SUPPLEMENTAL RESPONSES TO CEC STAFF DATA REQUEST SET 2 (18 AND 58)

Great Oaks South Backup Generating Facility (19-SPPE-
03)

SUBMITTED TO: CALIFORNIA ENERGY COMMISSION

June 2020

1 SV-12 - ROOF PLAN - OVERALL
1:300

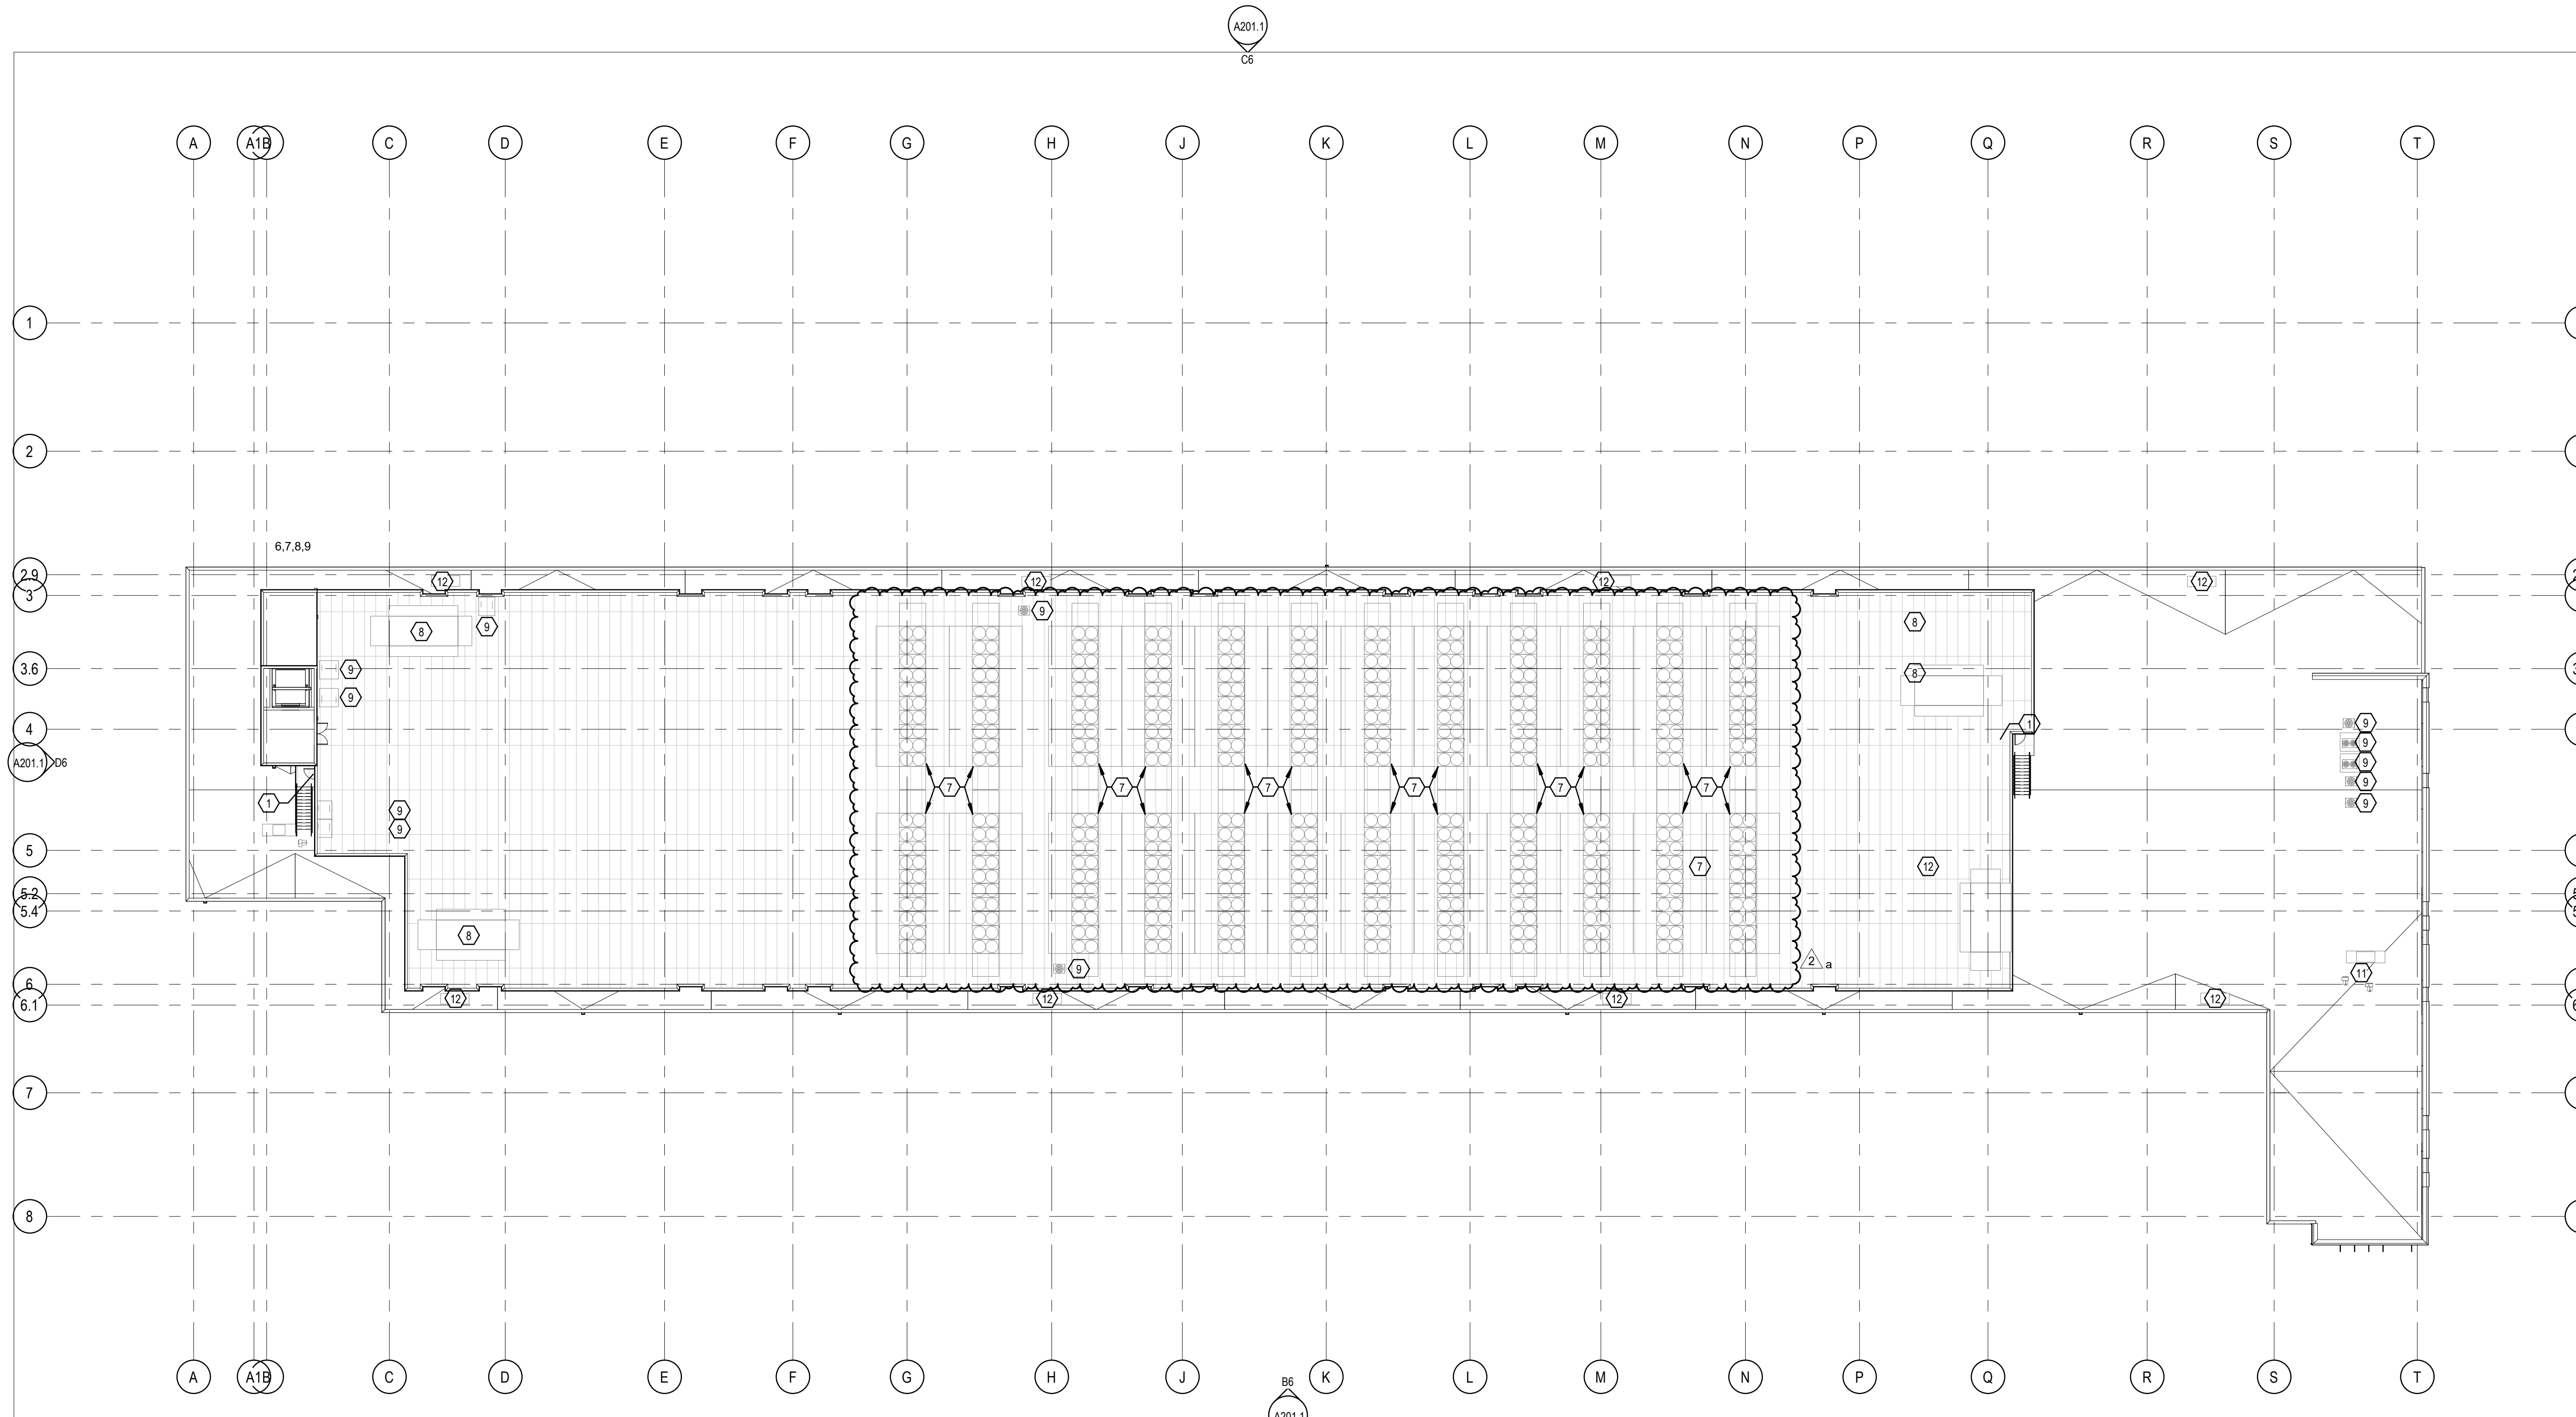
After further research into the recycled water issue, SV1 has made the decision to modify the cooling technology for the Great Oaks South Data Center by replacing the Water-Cooled Chilled Water system with Air-Cooled Chilled Water System with refrigerant-side economizer. The new mechanical system will consist of (72) total 400-ton chillers, (24) per building. Each building's cooling system will operate in a 22+2 redundancy configuration. Attachment UTIL DR-56 includes a modified roofing plan showing the locations of the chillers.

This project modification reduces the total water demand to less than 4 acre feet per year for all three data center buildings.

1	HOLLOW METAL STEEL EXTERIOR DOOR
2	LOCKING GATE DOOR WITH RIBBED METAL PANEL
3	GLAZED ALUMINUM CURTAINWALL SYSTEM
4	WINDOW GLAZING
5	EXTERIOR DUMPSTER
6	COILING DOOR
7	AIR CHILLER PLANT MODULES - SMARTD 400 TONS
8	DOAS MAKE UP AIR UNITS
9	CONDENSER UNITS
11	SUPPLY AND EXHAUST FANS
12	ELECTRICAL/MECHANICAL DOG HOUSE
